To: **Planning Commission**
From: **Melissa Sonnek, City Planner**
Date: **January 19, 2021**

Site Plan Review for the Construction of a Car Wash at 1949 Robert St. – Crew Carwash

Parking Breakdown

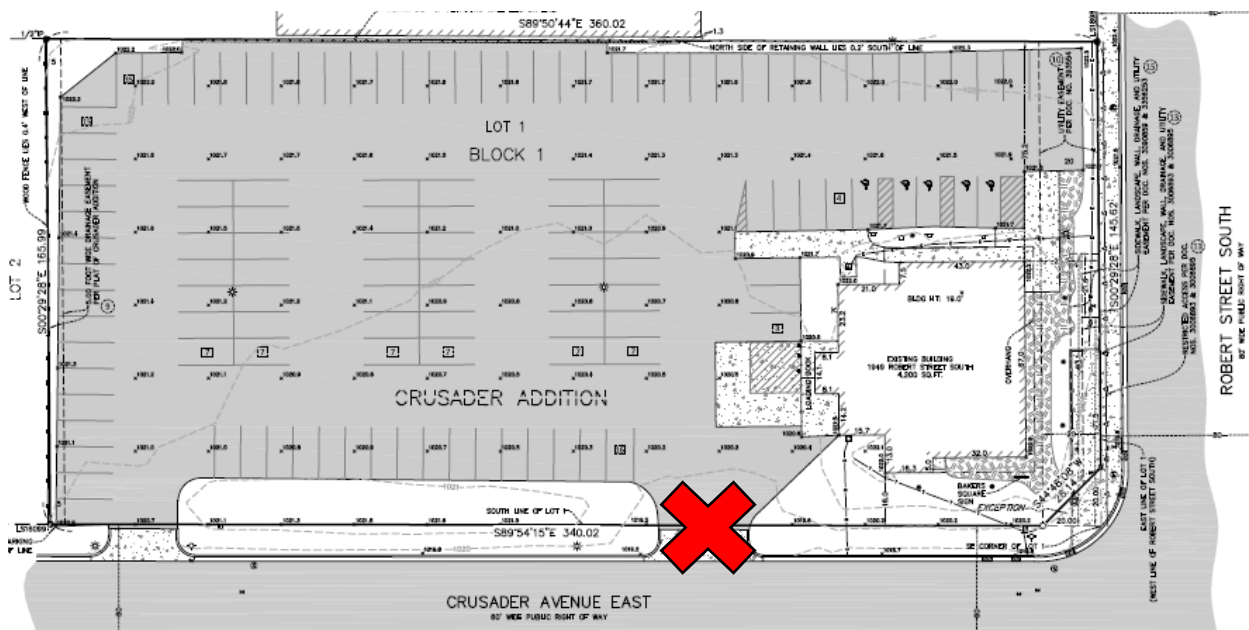
Parking requirements for car washes as a primary use requires stacking space for a minimum of 40 cars, the proposed plans allow sufficient stacking for 40 cars in queue for a car wash. As well as 15 parking spaces with a vacuuming station/amenity and 10 regular parking stalls to allow for employee and visitor parking.

- Stacking Room – 40 cars
- Vacuum Stalls - 15 stalls
- Traditional Stalls – 10

In order to keep the site clean and litter free, City Staff is recommending as a condition of approval that the site plan adhere to section 153.382(D)8 and provide a trash receptacle at each vacuuming station.

1. The applicant shall apply for and obtain all applicable building and sign permits,
2. The site plan shall be revised to adhere to section 153.382(D)8, and provide a trash receptacle at each vacuuming station,
